# 2020

# Updates

# STANDARD

DELAWARE DEPARTMENT OF TRANSPORTATION	INLET SEDIMENT CONTROL, DRAINAGE INLET		
	STANDARD NO.	E-4 (2020)	SHT. 1 OF

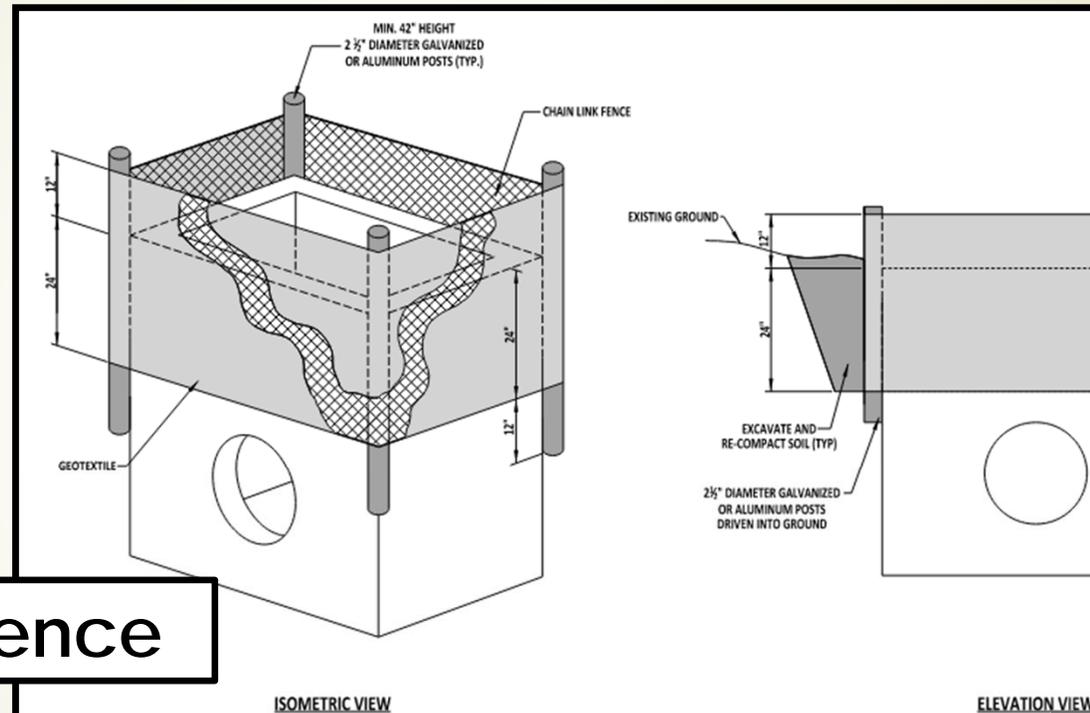
SILT FENCE uniformity

Use post and fence

INLET SEDIMENT CONTROL, CULVERT INLET  
STANDARD NO. E-5 (2020) SHT. 1 OF 1

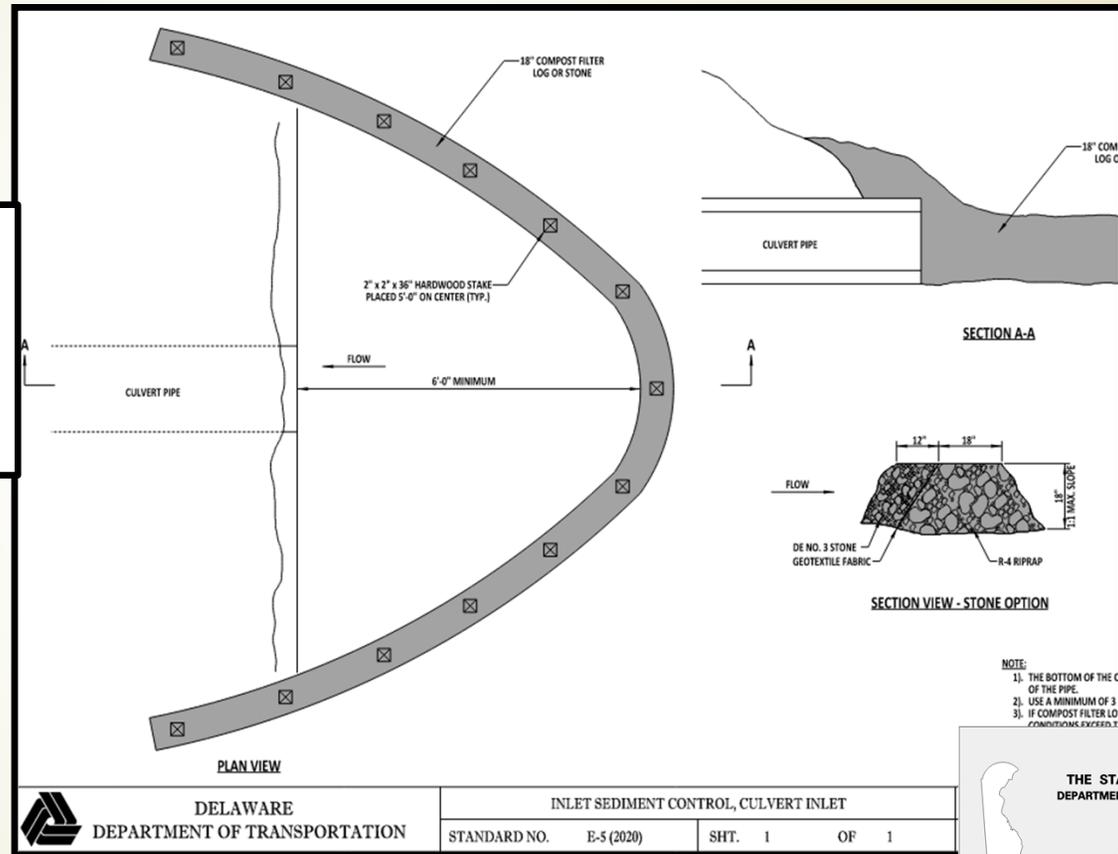
COMPOST FILTER LOG & STONE IS THE OPTION

**TEMPORARY PEDESTRIAN PATHWAY**  
N.T.S.

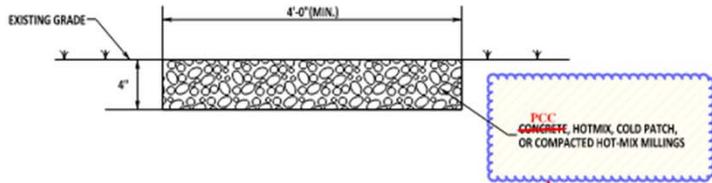
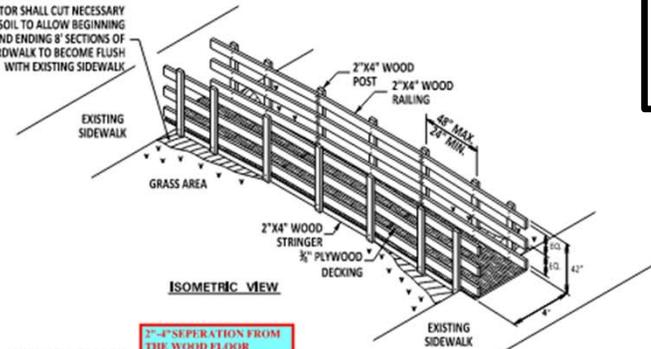
ADD NOTE: MAXIMUM ALLOWABLE RUNNING SLOPE NOT TO EXCEED 5%, MAXIMUM ALLOWABLE CROSS SLOPE NOT TO EXCEED 2% AND VERTICAL SURFACES NOT TO EXCEED 1/4". FURTHER GUIDANCE IN ACCORDANCE WITH THE LATEST VERSION OF THE Pedestrian Accessibility Standards for Facilities in the Public Right-of-Way.

CONTRACTOR SHALL CUT NECESSARY DEPTH OF SOIL TO ALLOW BEGINNING AND ENDING 8' SECTIONS OF BOARDWALK TO BECOME FLUSH WITH EXISTING SIDEWALK

ADD NOTE: MAXIMUM ALLOWABLE RUNNING SLOPE NOT TO EXCEED 5%, MAXIMUM ALLOWABLE CROSS SLOPE NOT TO EXCEED 2% AND VERTICAL SURFACES NOT TO EXCEED 1/4". FURTHER GUIDANCE IN ACCORDANCE WITH THE LATEST VERSION OF THE Pedestrian Accessibility Standards for Facilities in the Public Right-of-Way.
